JULY 20, 2026 REGULAR MEETING

Administrative Coastal Development Permit No. 26-029 / 31810 Cottontail Lane

Planning Commission Meeting
07-20-26
Item 3.B.1.

ENVIRONMENTAL HEALTH REVIEW SHEET

31810 COTTONTAIL LANE (ACDP 26-029)
MALIBU, CA 90265

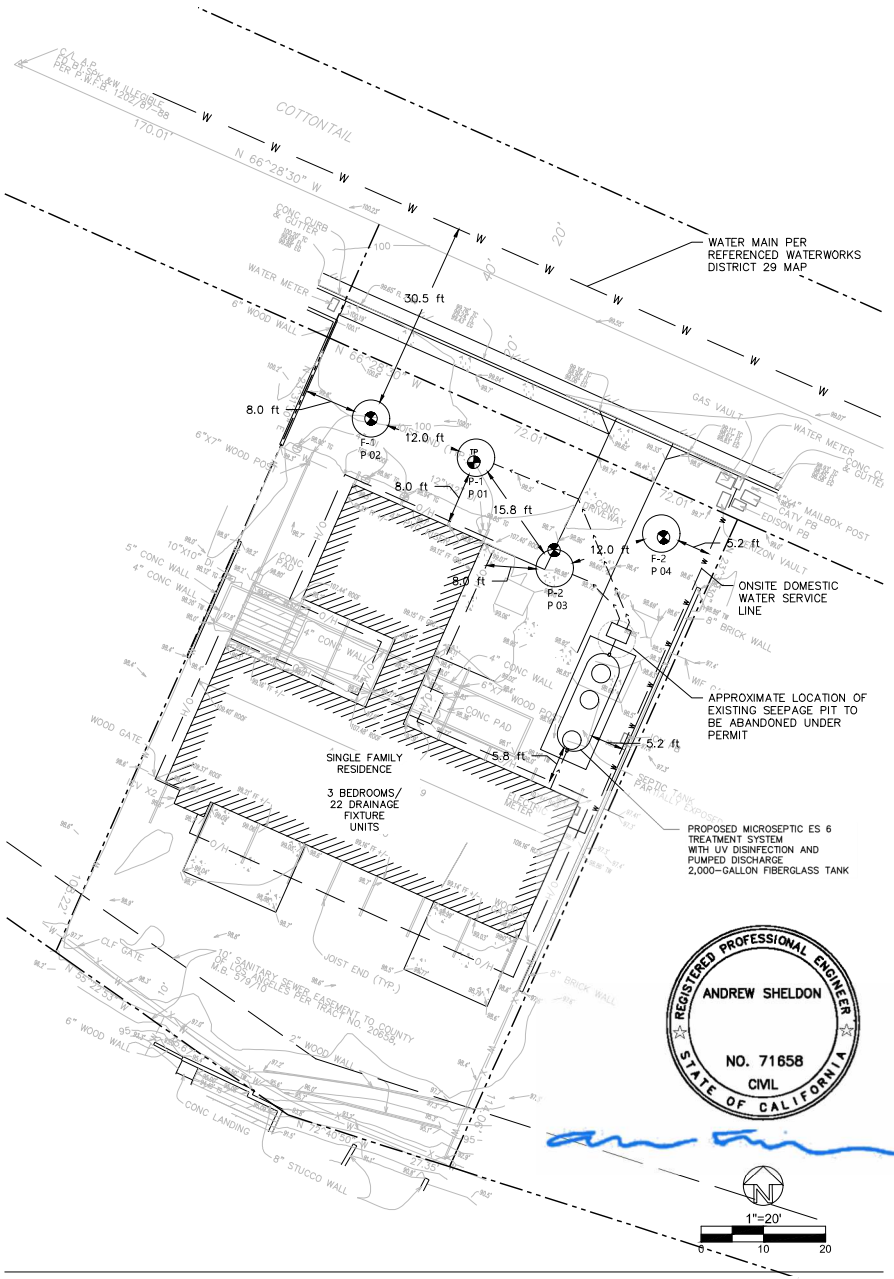
2) **Proposed OWTS Component Reconfiguration to Maintain Minimum Required Setbacks:** The Sheldon Engineering OWTS plot plan dated 3-27-2025 depicts proposed future expansion seepage pits that do not appear to meet the minimum required setbacks from the existing single-family dwelling and neighboring property line per the Malibu Municipal Code. (M.M.C.).

Please revise the final OWTS plot plan to shift the OWTS future expansion seepage pits so that all minimum required setbacks are maintained or provide reduction in setback letters from the OWTS and Geotechnical consultants pertaining to the future expansion seepage pit (P 02) located near the existing residence. An additional Environmental Health review fee of $949 is required for reductions in setbacks. The proposed future expansion seepage pit (P 04) located near the neighboring property line must be shifted to maintain all required setbacks per the M.M.C. – no reduction in setback will be approved for this pit.
